**LEANNE TOBIAS
ZONING OFFICER & BOARD MEMBER
SPRINGFIELD BETHESDA CIVIC ASSOCIATION
LITTLE FALLS PARKWAY
WRITTEN TESTIMONY
to the
MONTGOMERY COUNTY
PLANNING BOARD
March 30, 2023**

Little Falls Parkway: Against No-Median Configuration and Permanent Lane Closures

Little Falls Parkway Transportation Analysis

Figure 7: Little Falls Parkway Lane Use Design

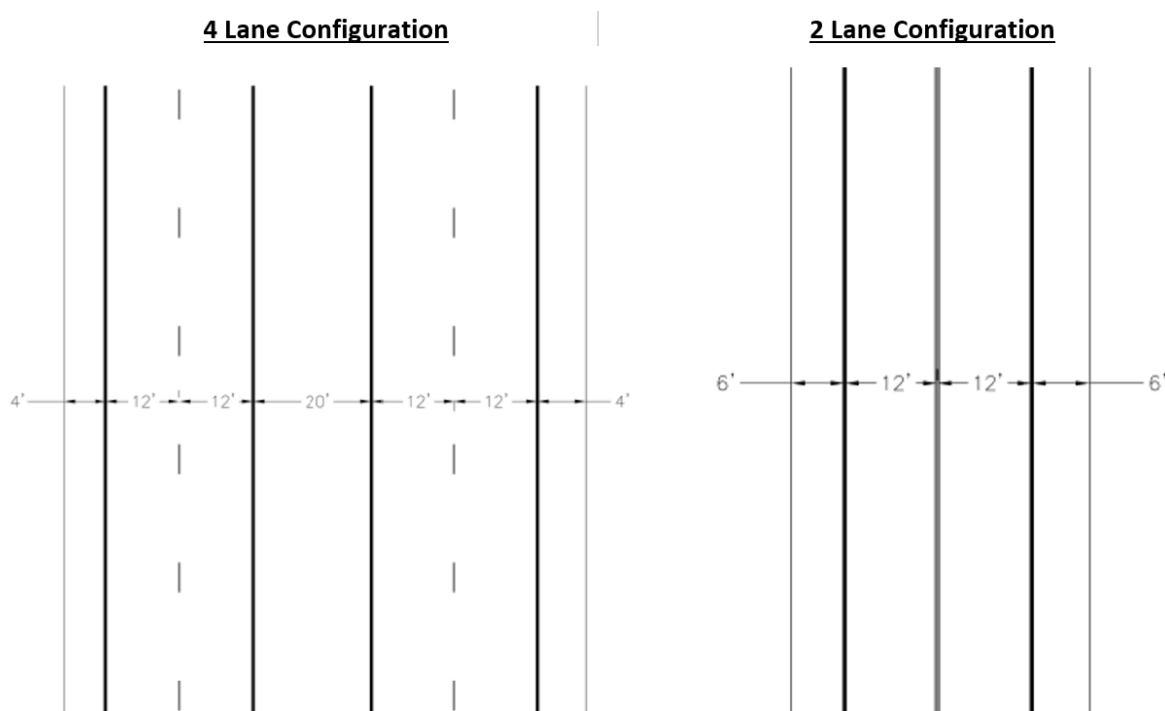
These roadway sections are shown in Figure 7. The current lane use along Little Falls Parkway from Dorset Ave. to Arlington Road has all of the traffic on the northbound side of the roadway. In the

This configuration violates the design intention of the roadway and causes problems when a vehicle becomes disabled or when emergency vehicles need to get through the section with cars not being able to effectively move out of the way.

This new configuration also violates driver expectancy, especially for northbound motorists who feel and observe that both lanes of the roadway are designed to go north. Especially for unfamiliar motorists, this can lead to confusion. At night and in rainy conditions, the double yellow line can become obscured and to the unfamiliar motorists, this could lead to them using the leftmost lane to go north, setting up the potential for collisions.

Figure 8: Alternative 1

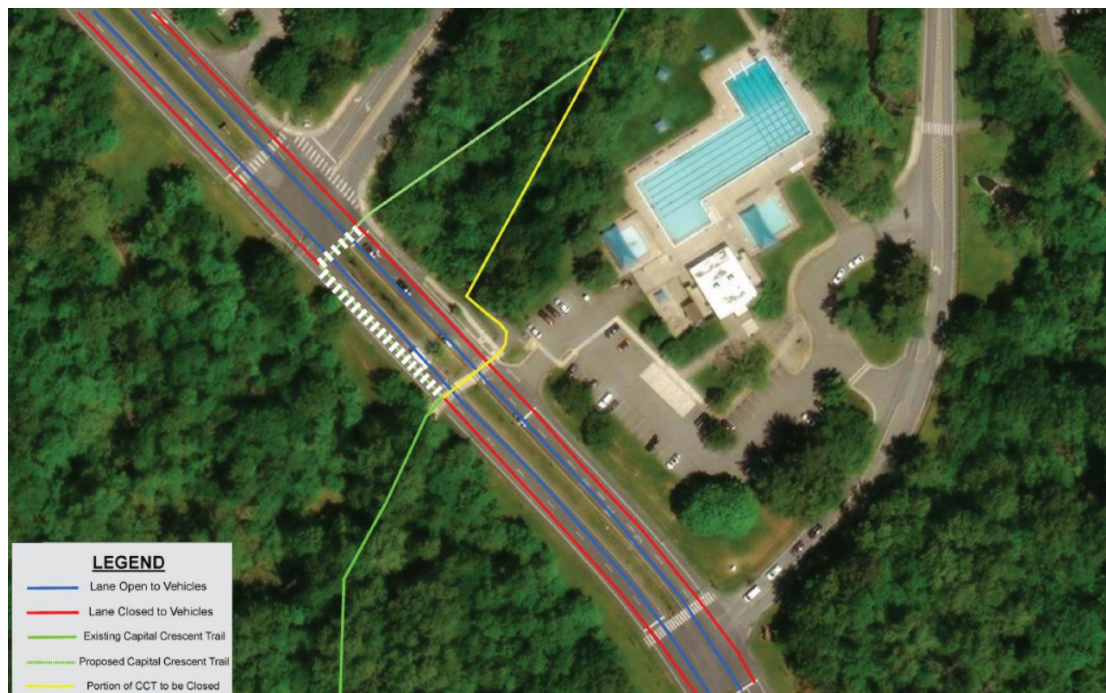
The first alternative is a low-cost alternative that would provide signal control at the CCT. This alternative is shown in Figure 8. This alternative relies on going back to the configuration started in 2017 and instead of keep the CCT crossing where it exists currently, it shifts the crossing to the intersection of Arlington Road. The pavement from the outside lane could be converted to a marked pedestrian path, and a new crosswalk on the south side of the intersection of Little Falls Parkway at Arlington Road would be installed to allow for crossing of pedestrians and bicyclists. The CCT would need to have a small section constructed in order to connect with the existing path.

Having the pedestrian traffic cross at a signalized intersection will increase safety by giving pedestrians the right of way for one of the traffic signal phases. It would also increase traffic capacity because there will no longer be vehicles stopping for pedestrians at the old CCT crossing.
